BWR OWNERS GROUP

Position on NRC Regulatory Guide 1.97, Revision 2

July 1982

FIGURE 6
RESULTS OF NRC CALCULATION

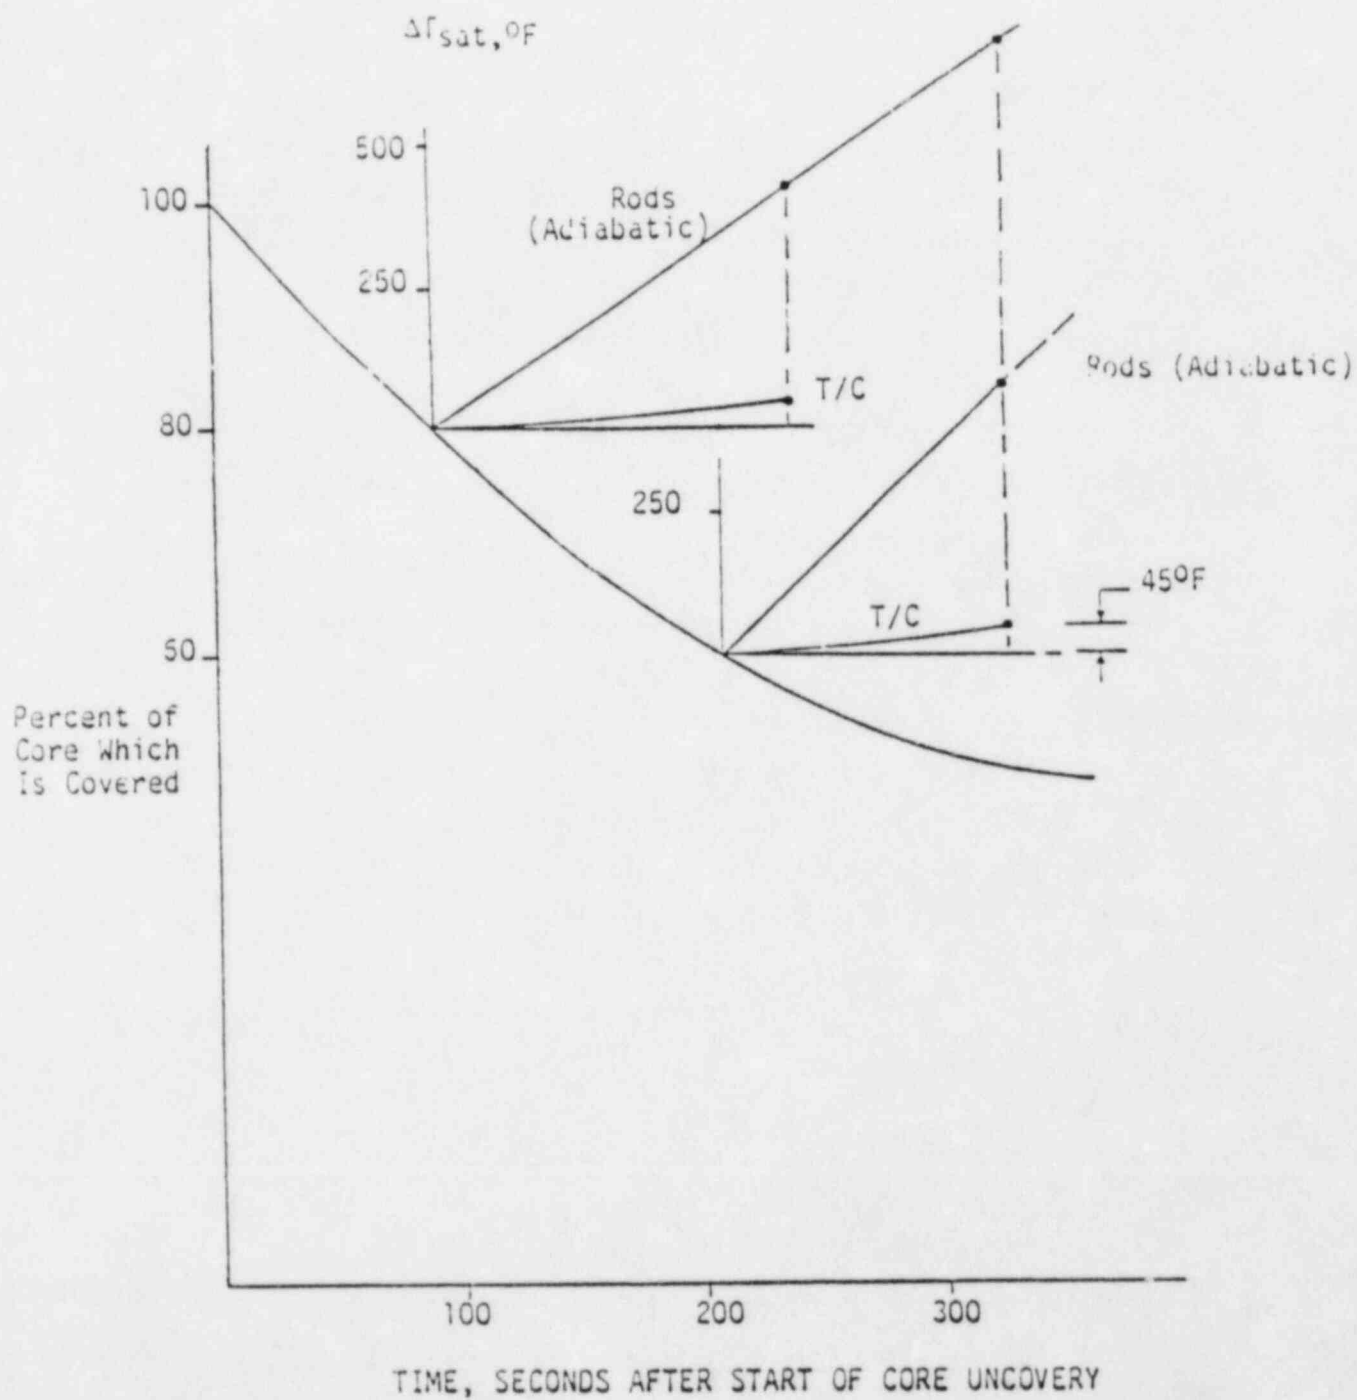
As part of this project, we have reviewed a calculation of the thermocouple response time by the NRC office of Nuclear Regulatory Research. Their calculation assumed a 2% of rated uniform axial power input and no convective heat transfer. They assumed that convection and radiation losses from the rods would be negligible. Their results are plotted in Figure 6. The adiabatic rod heat up rate which they calculated was about 2.7°F per second at the 80% of core height elevation (about 9.7 ft above B A F) and 3.8°F at the 60% core height elevation. With these heat up rates their results show that a thermocouple at the 60% height would show a 45°F temperature rise 120 sec after the 60% plane is uncovered.

The simple calculation in the last section shows that the adiabatic heatup rate should be on the order of 1°F/sec rather than the 2.7-3.8 that the NRC used. However, in order to compare our calculation to theirs, we adjusted the prescram power in our code (to 8,672 megawatts from 2436) and set the convective heat transfer coefficients equal zero. These results are shown in Figure 7. They agree very well with the NRC results. Using the NRC heatup rate our code predicts that a thermocouple at the 60% height will show 45°F temperature rise 135 seconds after the 60% plane is uncovered. The NRC calculated the 60% plane would uncover after 90 sec and the 80% plane after 210 sec. Our calculations, with their assumptions, shows these planes uncovering at 110 and 242 seconds respectively.

We conclude that the essential differences between our calculation and the NRC's are the extremely high heat up rates they assumed and the fact that they neglected convection to the passing steam. Both of these differences tend to make the calculated core temperatures rise more quickly after uncover which speeds up thermocouple response. We believe our assumptions are more realistic, and our results more correct.
